## **STANDARD FIELD SERVICE BULLETIN**

FSB Number	CHRAEFSB2018-8
Author	Tony Bryan
Date	02/23/2018
Subject	Moto G5 - No Speaker Audio
Model Affected	XT1670/71/72/75/76/77
Level Of Repairs	Level 2

**Figure 1.0 - Speaker Contacts Deformed**

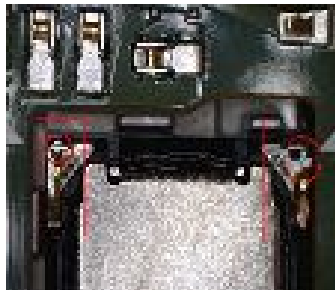
1. Speaker (p/n: 5SB8C07378): Speaker contacts may get deformed during Factory Assembly process as Rear Housing Assy is attached, resulting in intermittent connection. See Figure 1.0 below.

1. Speaker (p/n: 5SB8C07378): Contacts Deformed - Factory implemented a fixture to aid in Rear Housing Assembly and avoid deforming speaker contacts - Completed WK15 (April 15th) of 2017.
2. Rear Housing Assy (p/n: 5S58C0742x): Audio Flex Supplier improved their etching process to avoid trace damage - Completed WK26 (July 1st) 2017. See image below for Audio Flex date code markings.

**Figure 2.0 - Audio Flex - Open Trace**

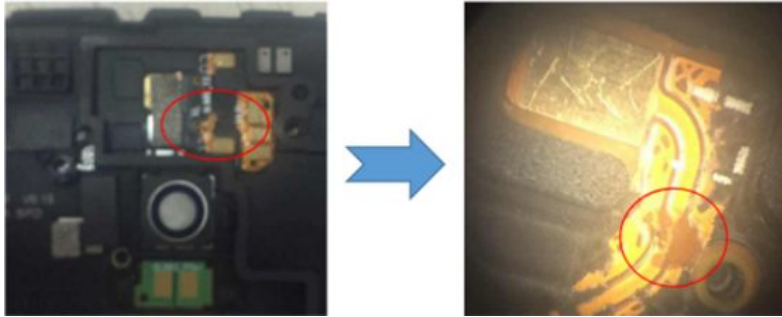
2. Rear Housing Assy (p/n: 5S58C0742x): The Audio Flex has an improperly formed trace from supplier's etching process, resulting in an open circuit condition. See Figure 2.0 below.
